FOR APPROVAL JAN 21 2021

LOCATION Tamlin RD., RV Storage / McDonalds Storage

STRUCTURE Pond A Outlet Structure

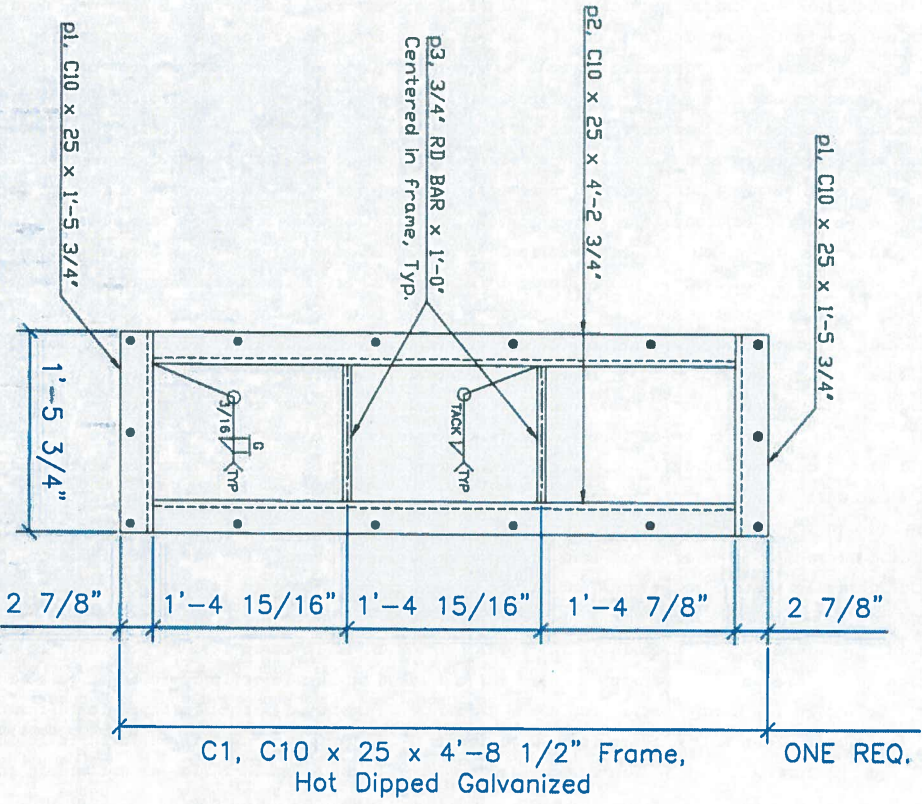
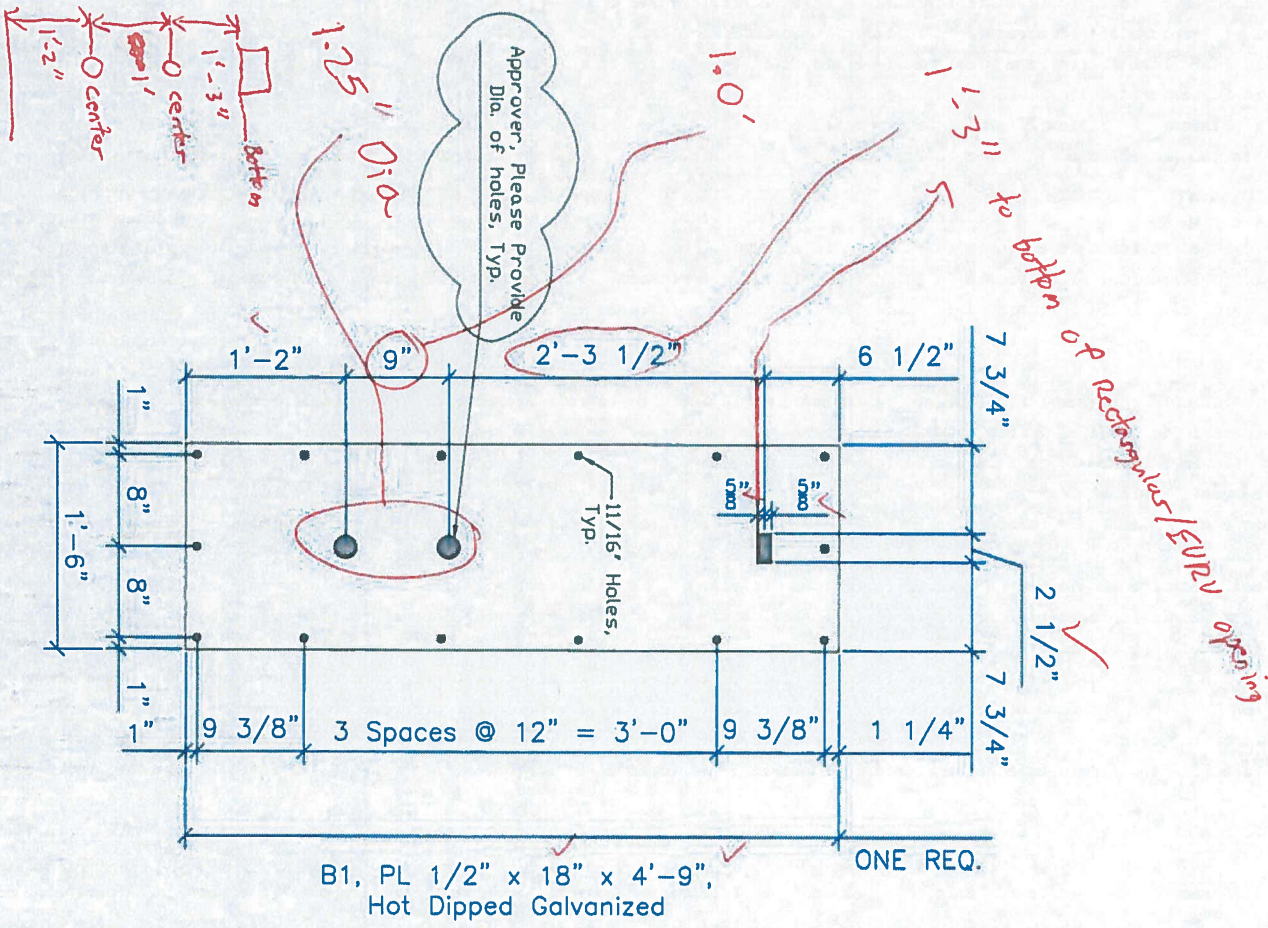
Approver, Please note, the span is greater than 3'-0". Thus, the bearing bars have to run the incorrect direction. Please Verify this is acceptable.
